ADDENDUM NO. 1

DATE: June 8, 2018

PROJECT: Marquette Area Public Schools Security Upgrades

1 STRUCTURAL WALL DETAIL
1/2" = 1'-0"

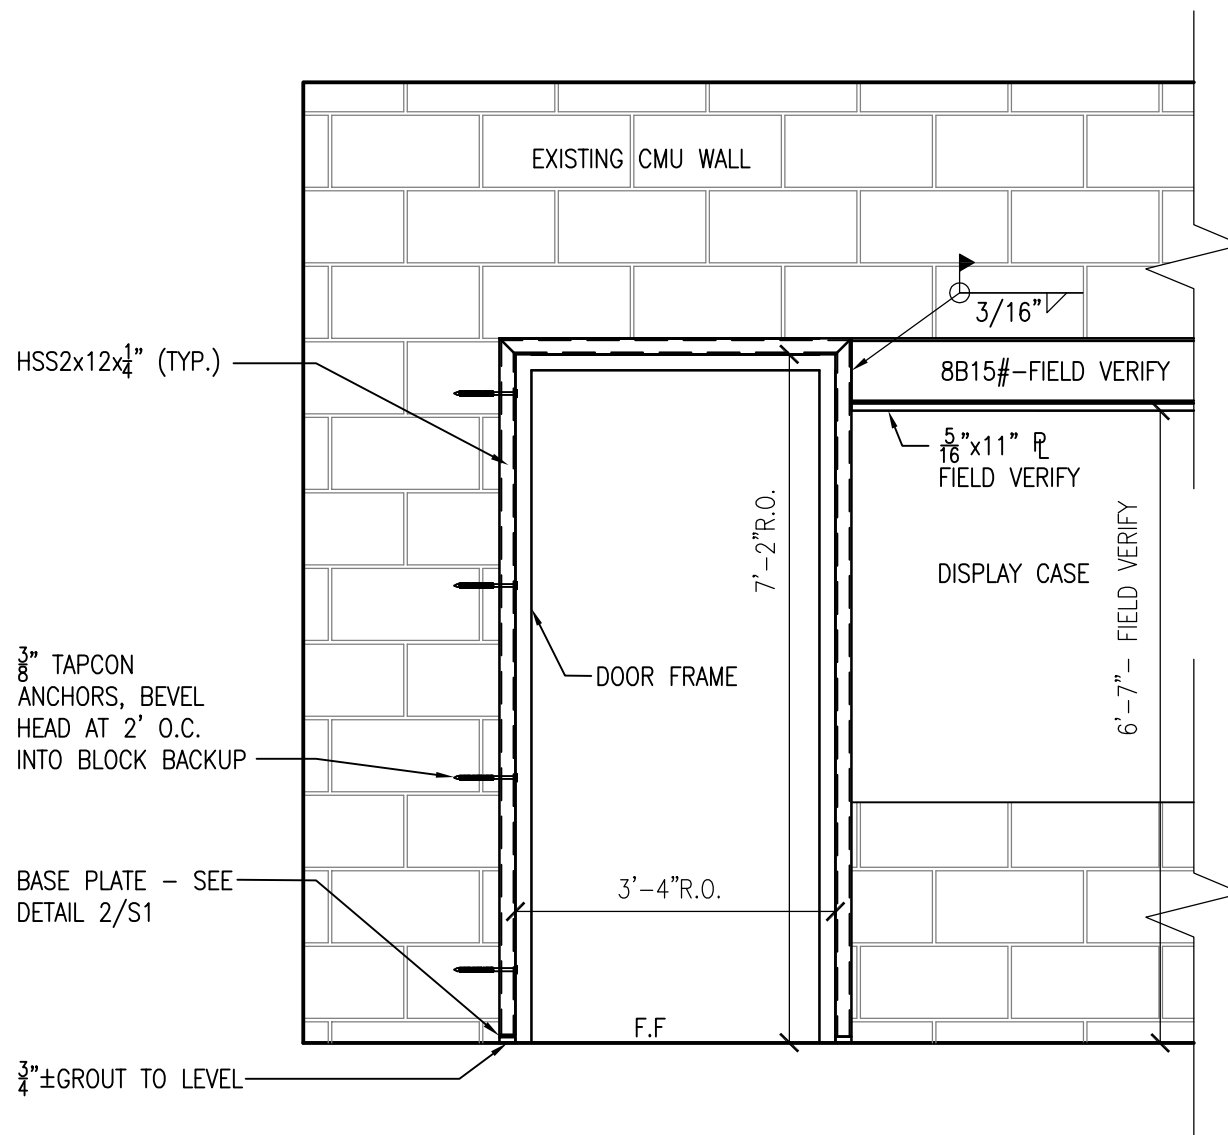
- Incorporate new steel frame at Door 106B. See sheet AD-1/S1. Contractor shall provide temporary bracing for opening and adjacent steel lintel as required as this door is located in a bearing wall.
- Contractor shall field verify dimensions prior to ordering steel frame and provide shop drawings for review and approval prior to construction.

1 VANDENBOOM PARTIAL ELECTRICAL DEMOLITION PLAN
 1/8" = 1'-0"

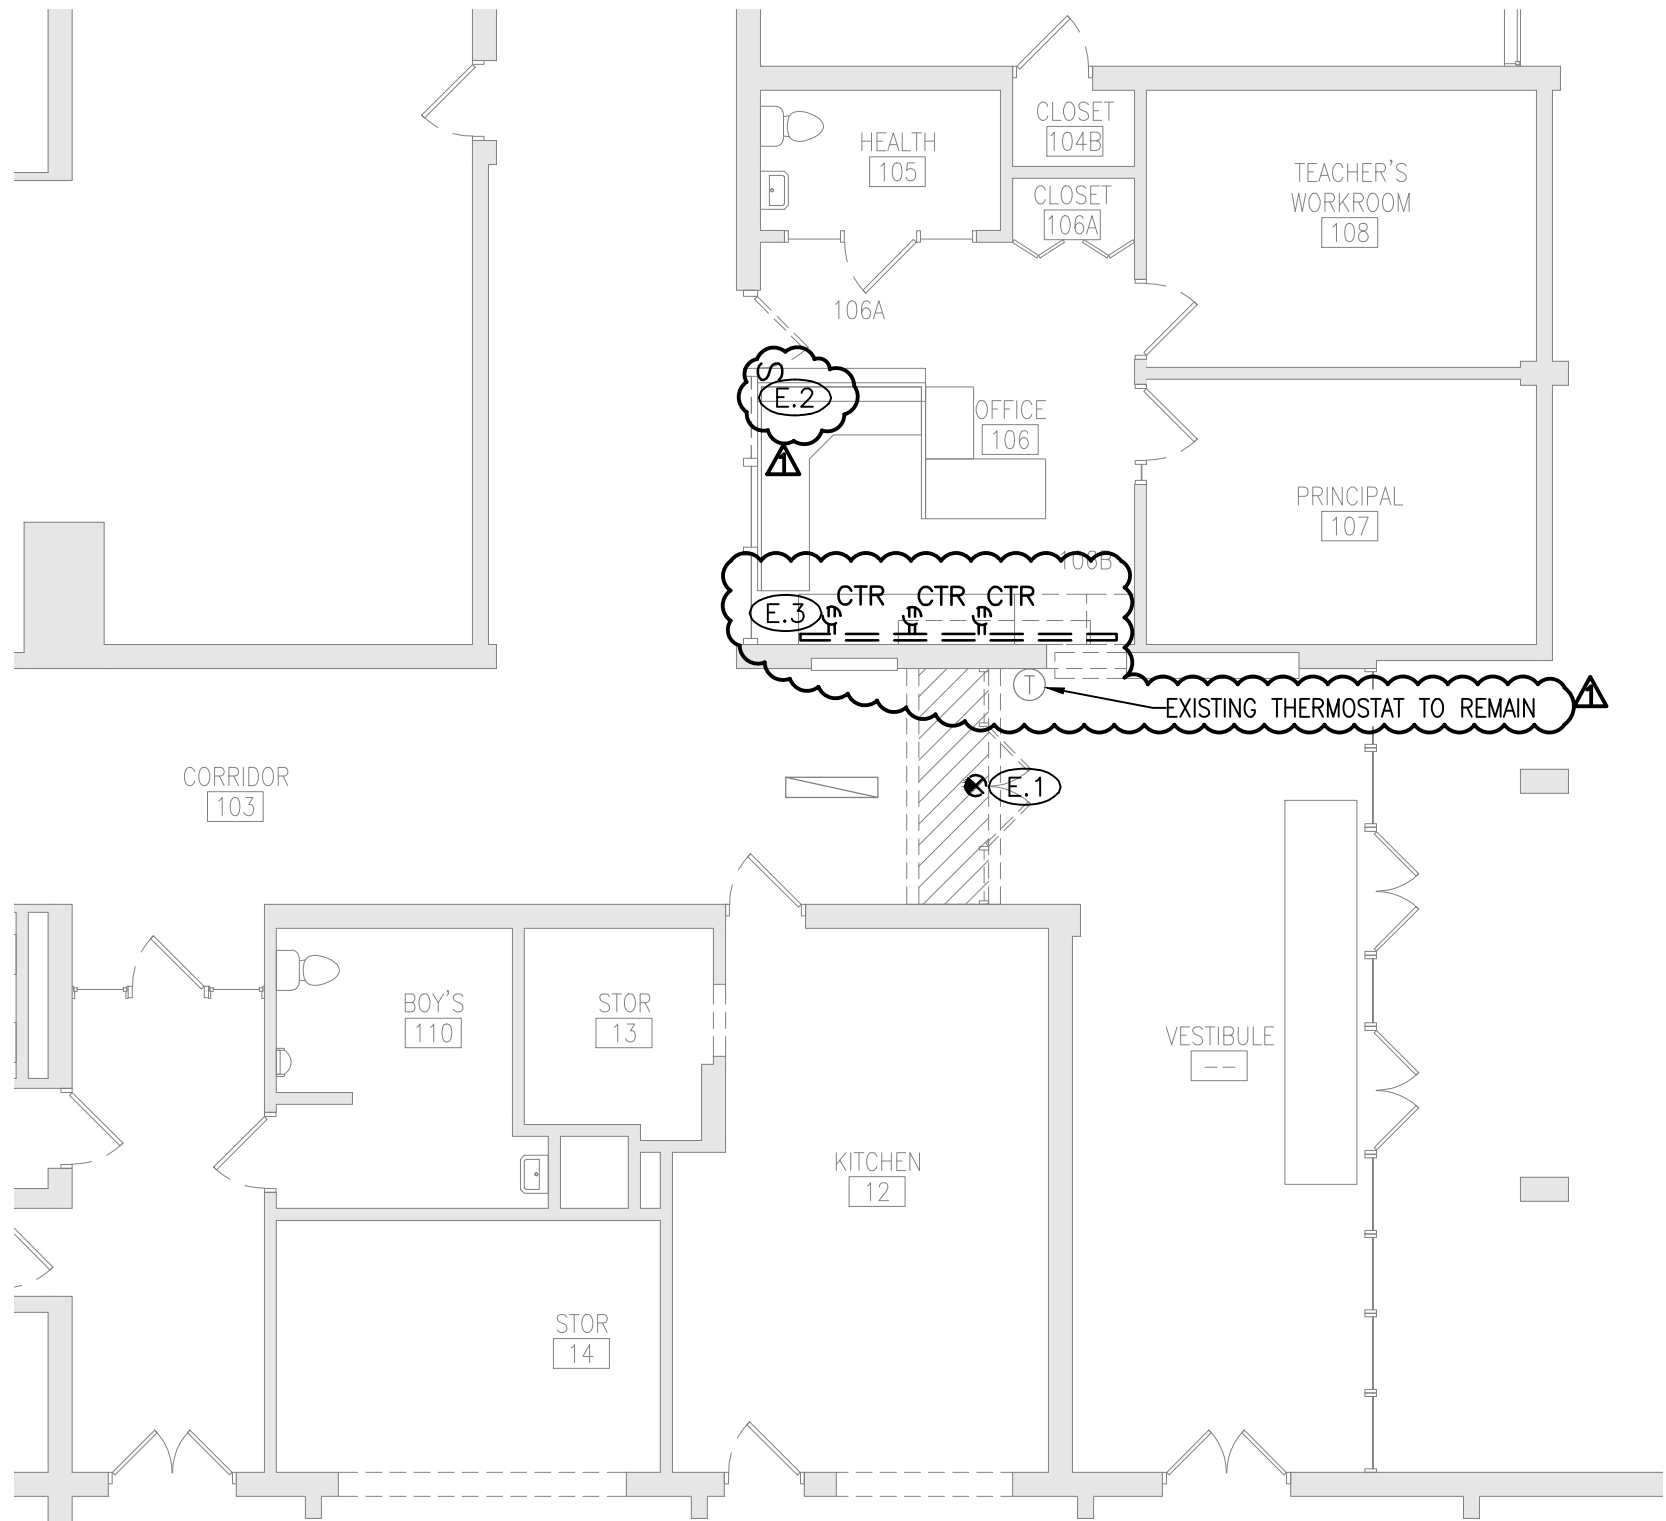
- Remove and reinstall light switch in storefront framing adjacent to Door 106A.
- Eliminate new light in corridor 103.
- Revise exit light in corridor 103 to be installed in new soffit immediately adjacent to storefront framing.
- Revise wiremold at countertop in Office 106.
